OBSERVATIONS ON SHANCLOON WINDFARM SID: P. Johnston

An Coimisiún Pleanála - Case reference: PAX07.323699

Shancloon Windfarm in the townlands of Beagh, Beagh More, Cloonbar, Cloonweelaun, Cloonnaglasha, Cloonteen, Corillaun, Derrymore, Ironpool, Shancloon, Toberroe and Tonacooleen, Co. Galway

Fig. 1 : The development site with principal drainage – brown areas are peat bogs (from EIAR Appendix 12.3:Flood risk assessment)

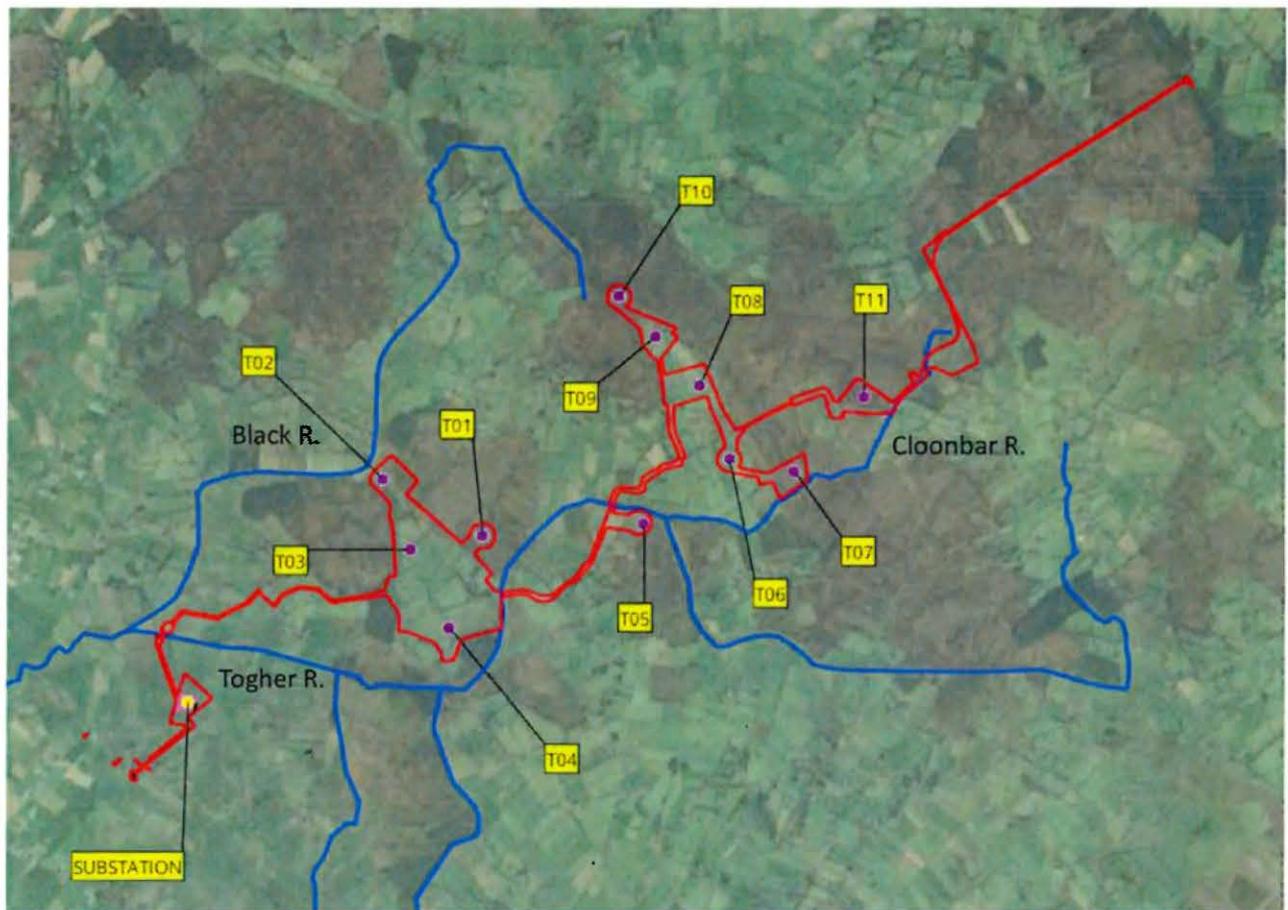
As shown in the EIAR (Fig.1), the development site is in the catchment of the Black River, mostly crossing the tributary catchments of the Togher and Cloonbar rivers. The flat landscape is essentially a mosaic of peatland and agriculturally reclaimed grassland, prone to flooding in spite of being part of a longstanding arterial drainage scheme. The site is within the Clare Groundwater Body which is the principal hydrological catchment area serving Lough Corrib, an SAC. The requirements of the Water Framework Directive (EU 2000/60) include the need to conserve the sources of water supply to the SAC. In this case the sources of supply are both groundwater and surface water and the development site is in the headwaters of both. The implications of the impact of the windfarm development on these sources of supply was not investigated in the EIAR, a serious deficiency in planning terms.
